SERVICE BULLETIN

Classification:	Reference:	Date:
BT19-011	NTB19-079	October 11, 2019

REAR PILLAR MOLDING REPLACEMENT

APPLIED VEHICLES: 2016 - 2019 Maxima (A36)

Figure 2

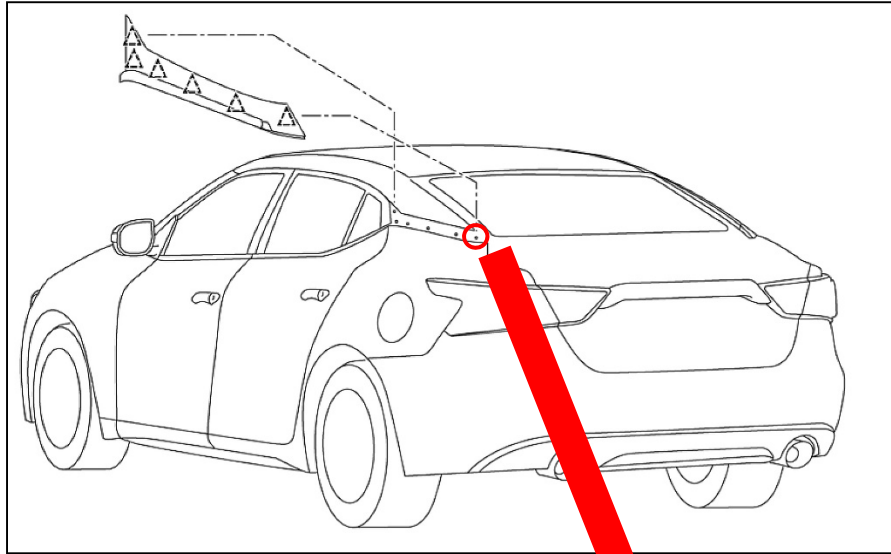
Mounting for the rear pillar molding on 2016 – 2019 Maxima now requires a 19/64th inch (7.5 mm) mounting hole for the rear clip and urethane adhesive installed in 2 locations. **ALL** rear pillar moldings on 2016 – 2019 Maxima must now be installed using this method.

1. Measure the rear pillar moldings rearmost clip mounting hole diameter.

HINT: Use a 19/64th inch (7.5 mm) drill bit to check mounting hole diameter.

Figure 6

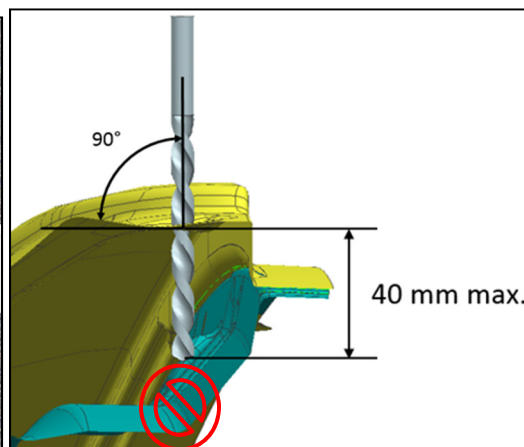
4. Drill a 19/64th inch (7.5 mm) hole no more than 1.57 inches (40 mm) deep.

To avoid damage to the vehicle, do not drill more than 1.57 inches (40mm) deep, otherwise the drill bit will contact internal body panels.

Figure 7

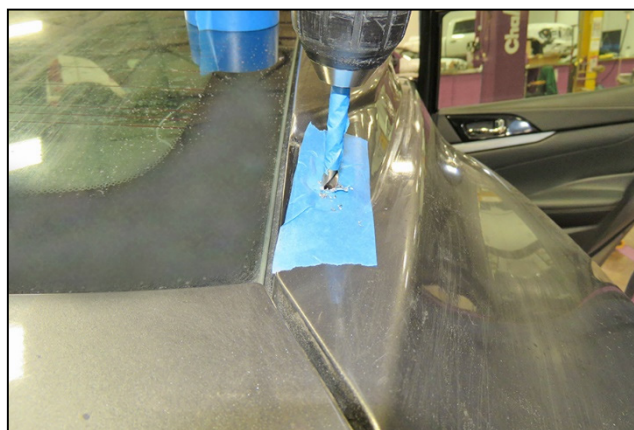
5. Clean all burrs and metal shavings from the drilled hole and surrounding area.
6. Coat the bare metal using a zinc-rich primer similar to RUST-OLEUM® Cold Galvanizing Compound shown in Figure 8.

Figure 14

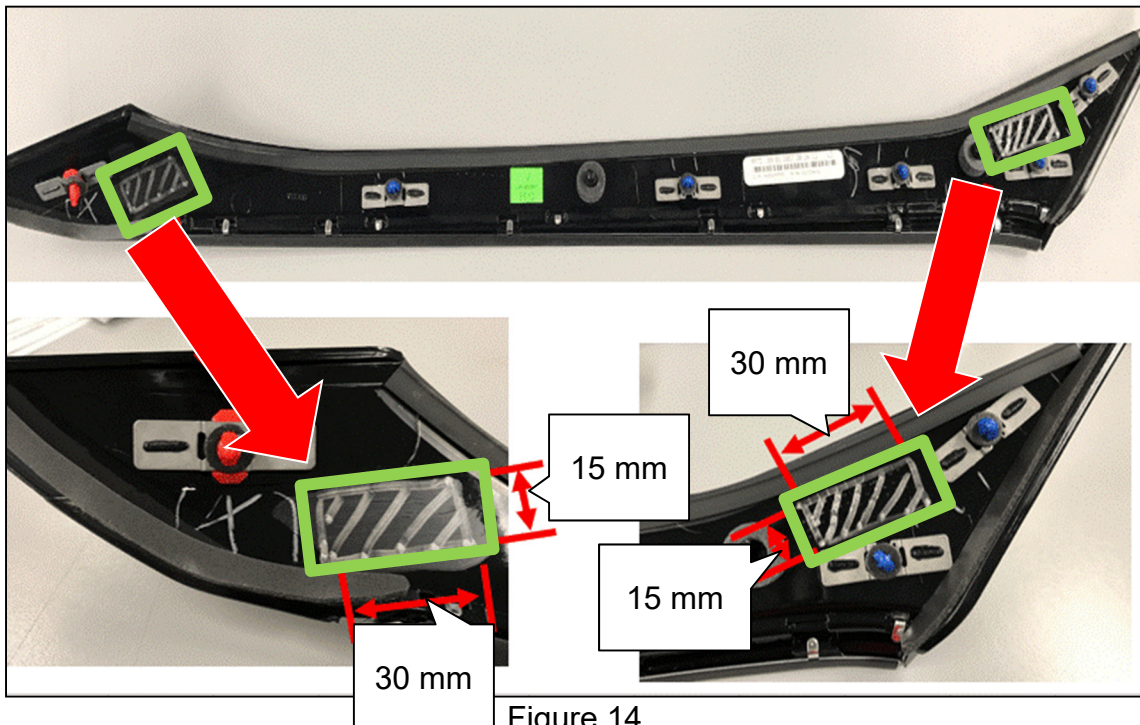
10. Apply Betaseal™ 43533 glass primer onto the newly cleaned rear pillar finisher areas shown in Figure 14, below.

Allow the Betaseal™ 43533 glass primer to dry for **AT LEAST 20** seconds or the urethane will **NOT** adhere to the rear pillar finisher.

Figure 15

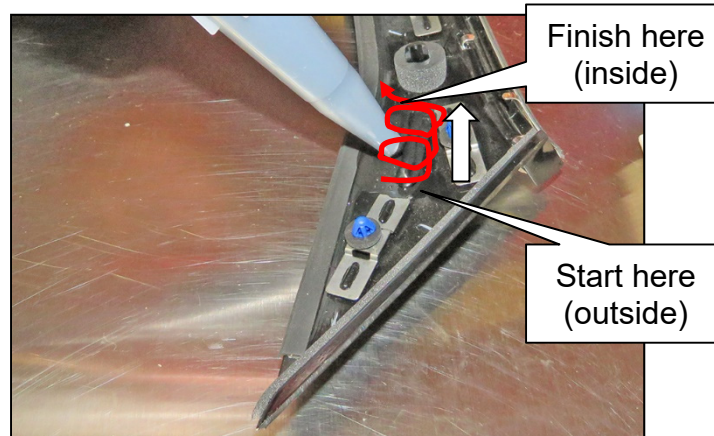
11. Apply Betaseal™ 57302N urethane in a **circular motion** starting from the **outside** to the **inside** of the rear pillar finisher, as indicated by the arrows in Figure 15 and Figure 16, below.

- Apply the urethane to a height of 8 mm and a width of 10 mm.
